Tazkia Apparels Ltd.

11 December 2025

Structural Inspection Report

Observation-02: Hairline cracks on beam and slab (Main Production Building)

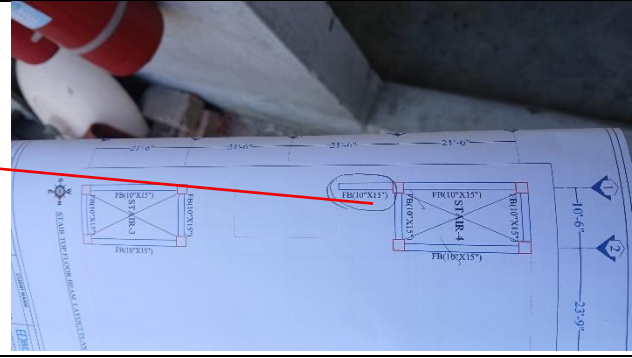
Description: During the inspection, hairline cracks were found on beam and slab at 5th floor roof. The building engineer is required to investigate the extent of crack and prepare an investigation report with remedial measures and submit it to RSC for review.

6.	Hairline cracks on beam and slab (Main Production Building)	The building engineer is required to investigate the extent of cracks and prepare an investigation report with remedial measures and submit it to RSC for review. Repair the crack as per the RSC accepted investigation report.	within 6 weeks

Missing cantilever beam on stair roof

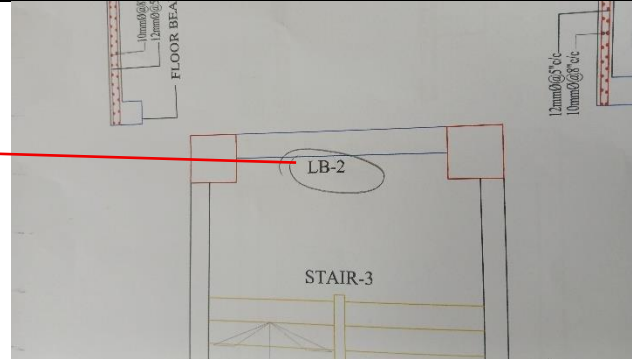
Description: During the inspection, several mismatches were observed between the as-built drawings and on-site conditions. The building engineer is required to survey the full structure and update the as-built drawing as per site conditions.

7.	Mismatch/Lack of information in the as-built drawing. (Main Production Building)	The building engineer is required to survey the full structure and update the as-built drawing as per site conditions.	within 6 weeks
